To: T10 Technical Committee
From: Rob Elliott, HP (elliott@hp.com)
Date: 3 March 2005
Subject: 05-100r0 SAS-1.1 Compact cable sideband usage

Figure 1 — Compact connector sideband usage example

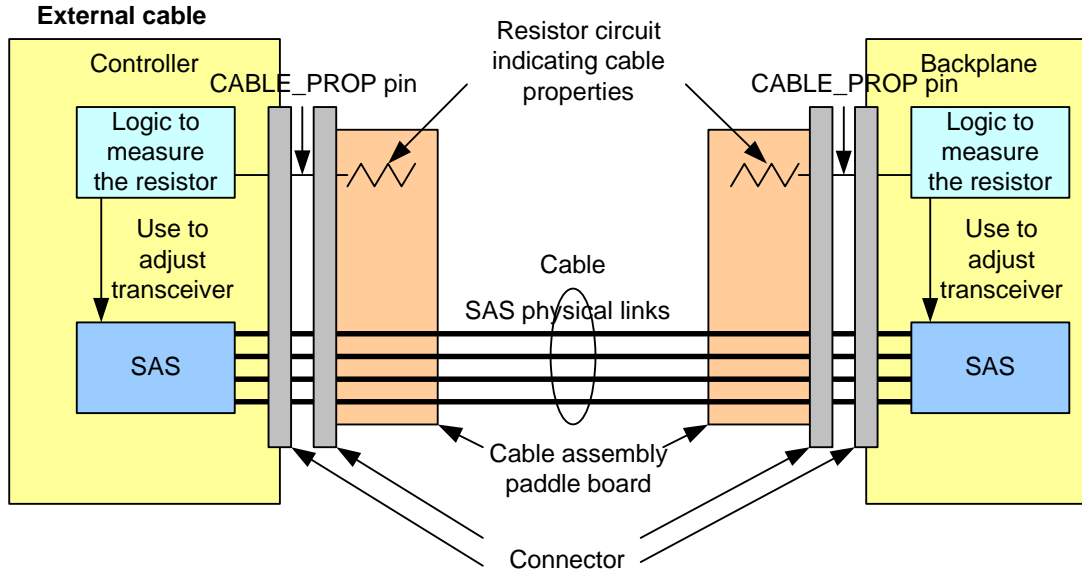
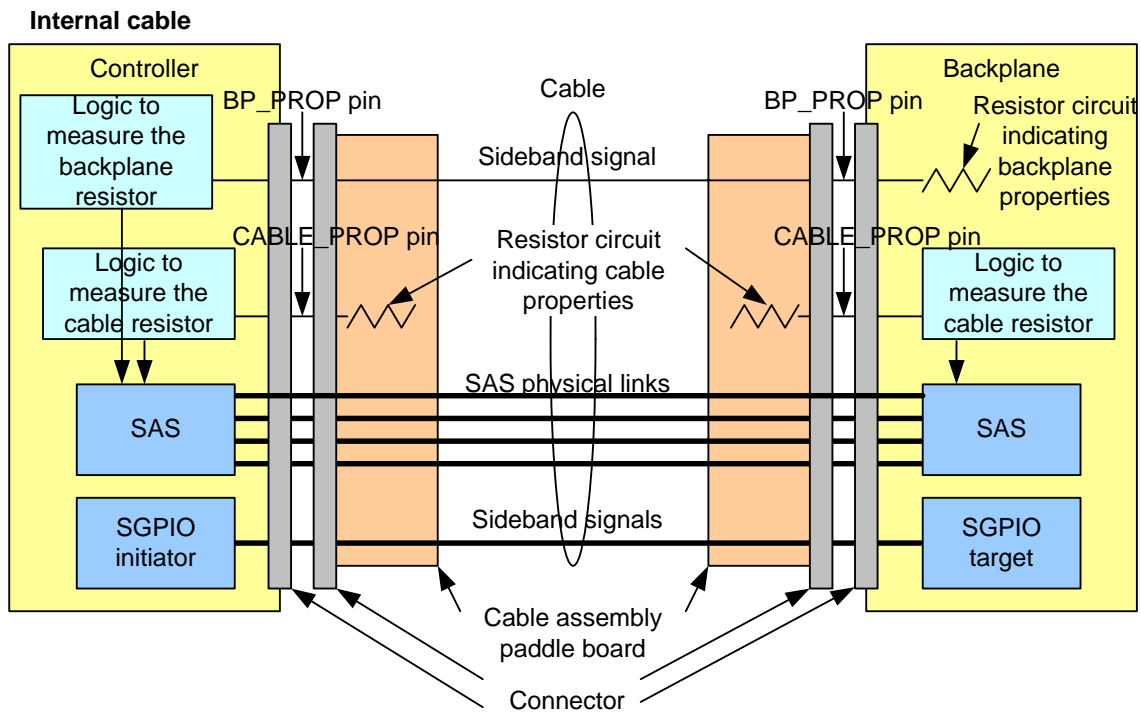
Figure 1 depicts the proposed sideband usage.

CABLE_PROP indicates the properties of the cable.

CABLE_PROP indicates the properties of the cable (not as important as for external cables).
BP_PROP indicates the properties of the backplane.

In SFF-8086 and SFF-8088 (external), add at least one cable-assembly terminated sideband signal.

In SFF-8086 and SFF-8087 (external), terminate one of the sideband signals at the cable-assembly rather than wire it through.

In SAS-1.1 or SAS-2, define the signal assignments for CABLE_PROP and BP_PROP, define the circuit and set of resistor values, and the define the meaning of each of those resistor values.
